PG&E Letter DCL-04-104

Docket No. 50-275, OL-DPR-80
Docket No. 50-323, OL-DPR-82
Diablo Canyon Units 1 and 2
Response to NRC Request for Additional Information Regarding License
Amendment Request 04-01, "Revised Steam Generator Voltage-based Repair
Criteria Probability of Detection Method for DCPD Units 1 and 2"

PG&E Response to NRC Request for Additional Information Regarding License Amendment Request 04-01, "Revised Steam Generator Voltage-Based Repair Criteria Probability of Detection Method For DCPD Units 1 and 2."

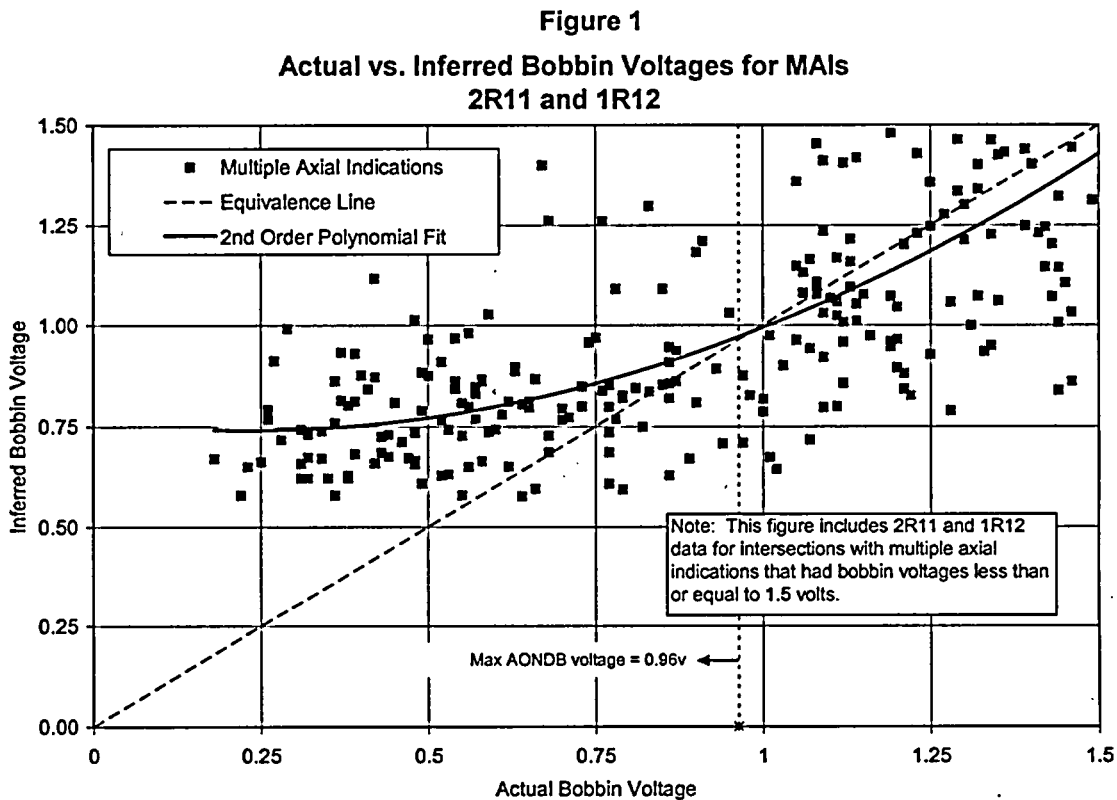
In the fifth bullet on page 9 of Enclosure 1 to your submittal, you indicate that if the RPC inspection identifies more than one ODSCC indication at the same TSP intersection, the bobbin voltage assigned to the TSP is estimated as the square root of the sum of squares (SRSS) for the bobbin voltages inferred from the RPC indications. Please clarify if this technique is only used in instances where the indications are only detected by rotating probe and a review of the 200 kHz bobbin data does not identify a flaw (i.e., should it be considered a sub-bullet to the fourth bullet). Please provide data supporting the adequacy of this approach. For example, provide data in which bobbin indications were RPC confirmed as multiple axial indications and compare the bobbin voltage for these indications to the voltage obtained using the square root of the sum of the squares approach applied to the rotating probe voltages.

The technique described in NRC Question 5 is only used in instances where the indications are only detected by rotating probe and a review of the 200 kHz bobbin coil data does not identify a flaw. In the most recent outages at each unit, Unit 1 refueling outage 12 (1R12) and Unit 2 refueling outage 11 (2R11), there were a total of 129 intersections identified as containing AONDB. Only twelve of these intersections contained multiple axial indications and were subjected to the SRSS method for determining the inferred bobbin voltage. PG&E previously provided information on the progression of AONDB indications in a response to NRC questions on the 1R11 inspection results in PG&E Letter DCL-03-113, "PG&E Response to NRC Questions on 1R11 Steam Generator Tube Inspections," dated September 15, 2003 (see response to ODSCC ARC Question 2).

Figure 1 below shows the inferred bobbin coil voltages plotted against the actual bobbin coil voltages for the intersections which were confirmed as having multiple axial indications by Plus Point coil. This figure includes intersections that had bobbin coil voltages of less than or equal to 1.5 volt and includes data from the most recent inspections performed during DCCP Unit 2 Refueling Outage No. 11 (2R11) and Unit 1 Refueling Outage No. 12 (1R12). The 1.5 volt cutoff was selected based

on the maximum inferred voltage for an AONDB flaw. The maximum AONDB voltage over the last two inspections was 0.96 volts. This inferred voltage was for an intersection that had two axial indications and was taken from a population of 129 intersections with inferred AONDB voltages. As shown in Figure 1, the inferred bobbin coil voltages are overpredicted on average in the area of interest (less than 1 volt). Since the SRSS method for estimating a bobbin coil voltage is only used in cases where a bobbin coil signal is not detected (i.e., small indications), this method is deemed appropriate and conservative.

A polynomial fit of the inferred to actual voltage data is also shown in Figure 1 below, and reflects the influence of the overestimates for the inferred voltages below about 1 volt.
